## Version 107 Update

Version 107 (12/12/19) software is now available for download at [DMP.com/Dealer\\_Direct](https://www.dmp.com/Dealer_Direct). Effective April 13, 2020, all SCS-150 software will be manufactured with Version 107 software.

Figure 1: CID String Example

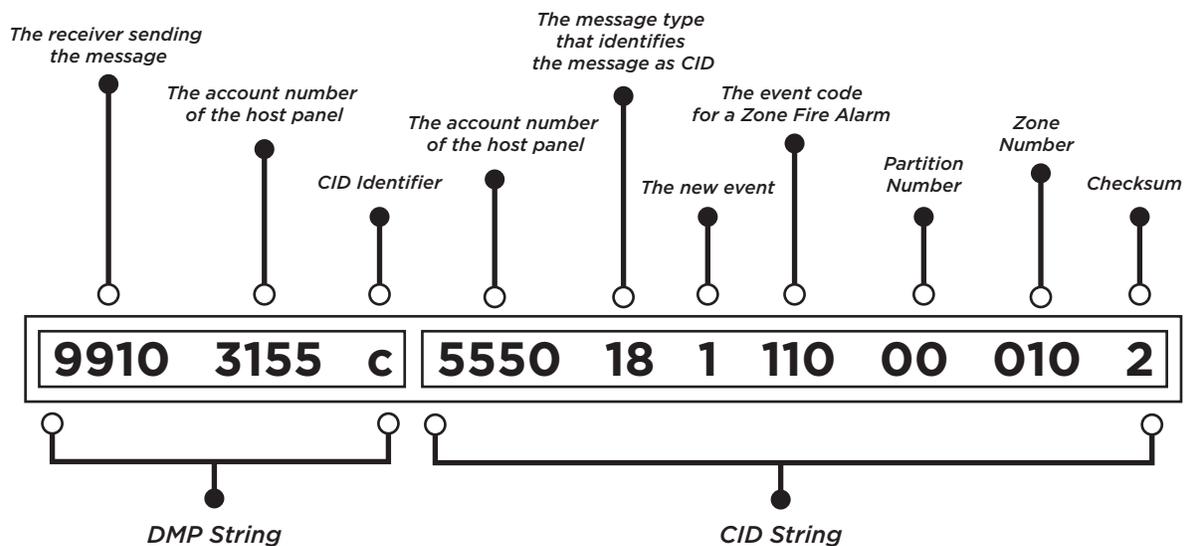
This feature has been added to support the upcoming version 202 firmware of DMP Universal Communicators. This will allow the receiver to process Serial 3 messages received that contain CID (ContactID) event codes within the message. Upon receipt of those messages, it will process only the CID portion of the message out to the Central Station Automation.
